CITY PLANNING COMMISSION
1231 "I" STREET, SUITE 200, SACRAMENTO, CA 95814

- APPLICATION:**
- A. Negative Declaration
 - B. Lot Line Adjustment to merge three lots into two lots totaling 6.3± vacant acres in the Light Industrial, M-1, and Heavy Industrial, M-2, zones

LOCATION: 3000 Academy Way

PROPOSAL: The applicant is requesting the necessary entitlements to merge three lots into two lots totaling 6.3± vacant acres in the Light Industrial, M-1, and Heavy Industrial, M-2, zones in order to build a 23,758 square foot warehouse building on one of the lots.

Site Plan

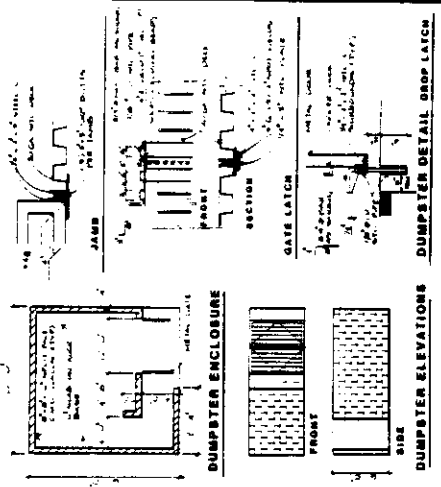
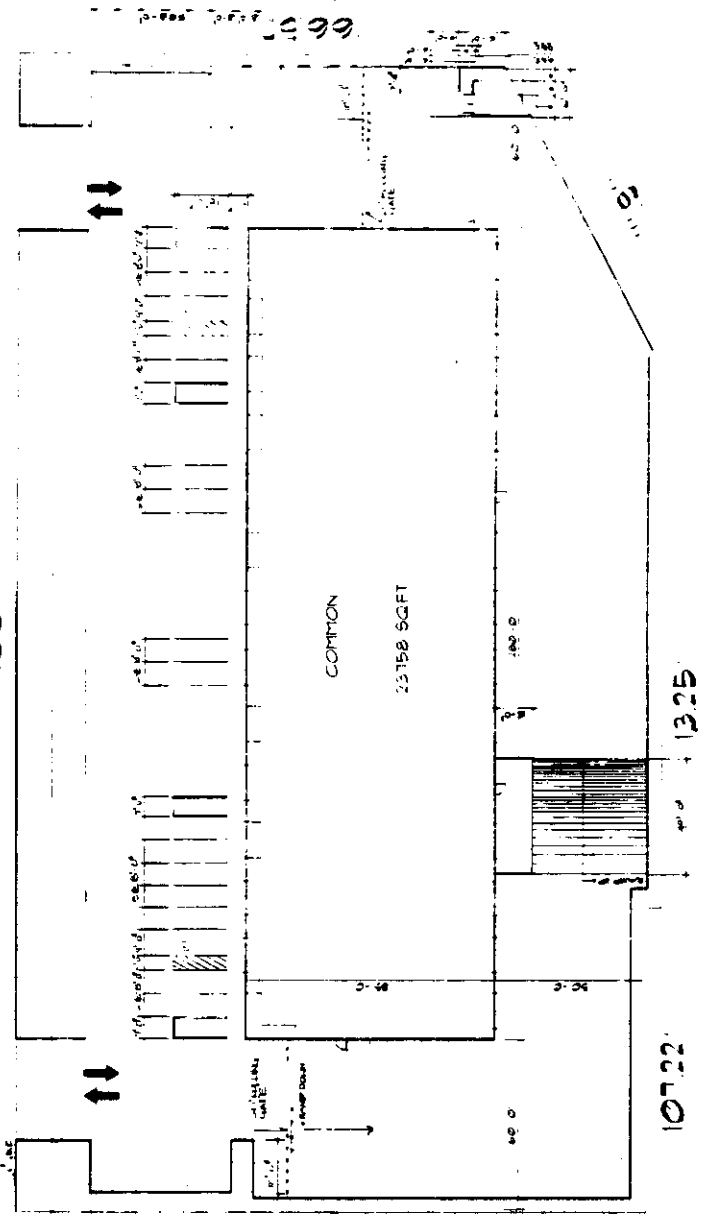
The trash enclosure must meet the trash enclosure regulations in the Zoning Ordinance. No setback is required for the proposed building. The applicant is providing a 78 foot front setback, a 27 foot rear setback on the diagonal rear property line, and a 60 foot setback on the west side. The trash enclosure is along the east side property line. The setbacks for the lot to be developed are zero on all four sides. A sign permit must be obtained for any proposed sign.

Traffic Engineering staff requested that driveways shall match or have a 120 foot offset from existing streets (Juliesse Avenue) and other driveways on the opposite side of Academy Way. Also, driveways shall be a maximum of 45 feet wide and shall conform to the City's Driveway Ordinance.

FLOOR PLAN
SCALE: 1/8" = 1'-0"

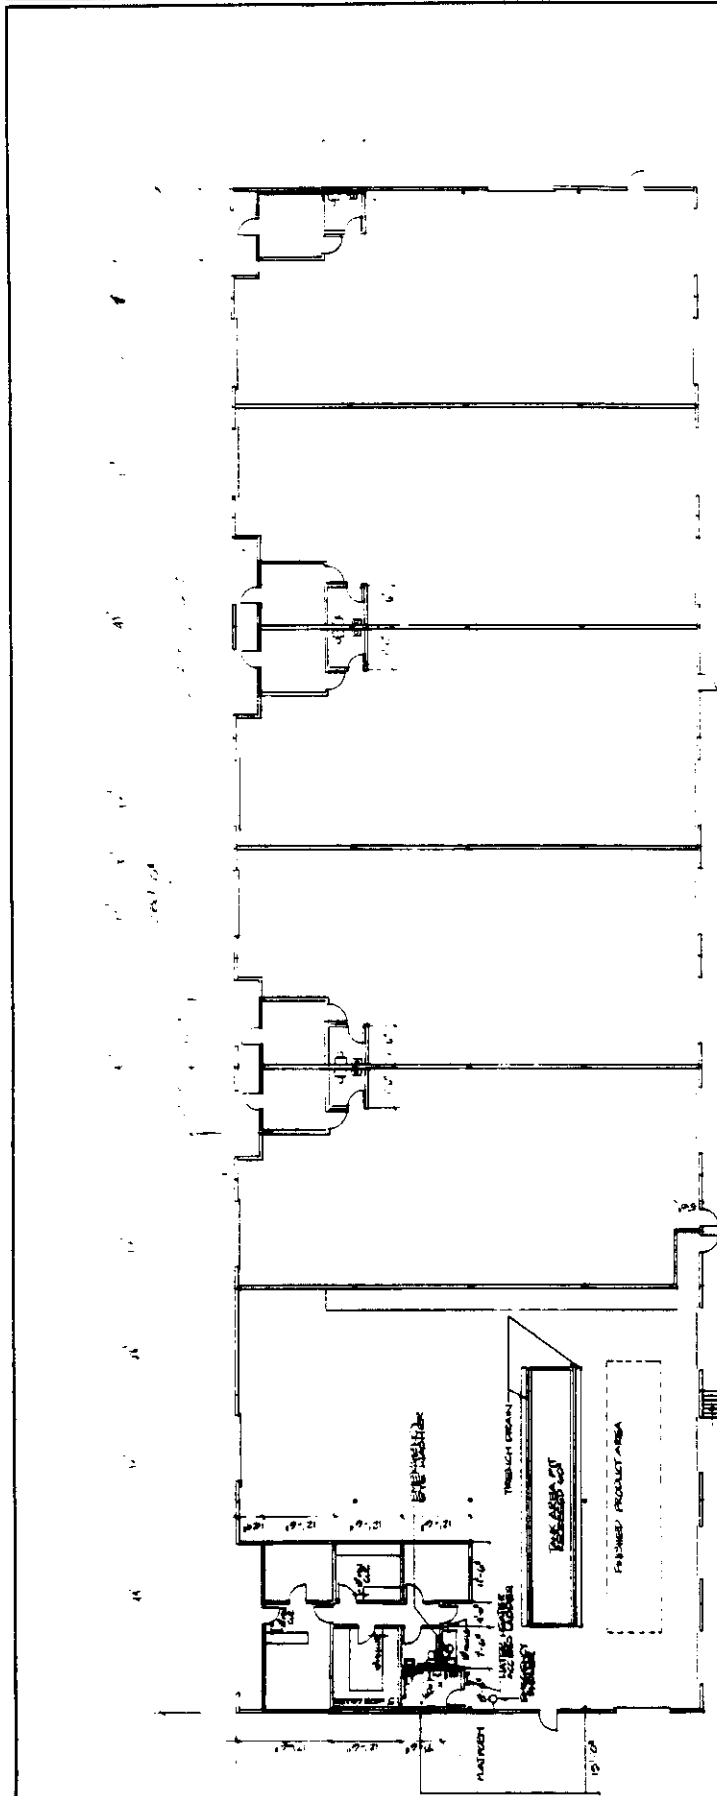
According to the Zoning Ordinance, offices are allowed by right in the M-1 and M-2 zones only if offices are incidental to an industrial use and do not occupy more than 25 percent of the building area. The applicant is indicating a maximum of 20 percent office. If at any time in the future, greater than 25 percent office is proposed, a Planning Director's Special Permit shall be required if the office is 10,000 square feet or less or a Planning Commission Special Permit shall be required for a larger office.

According to the Zoning Ordinance, one parking space is required for every 1,000 square feet of warehouse building area and one parking space is required for every 400 square feet of office. The applicant is proposing a 23,758 square foot building with 20 percent office. A total of 31 parking spaces are required. The applicant is providing 33 parking spaces.
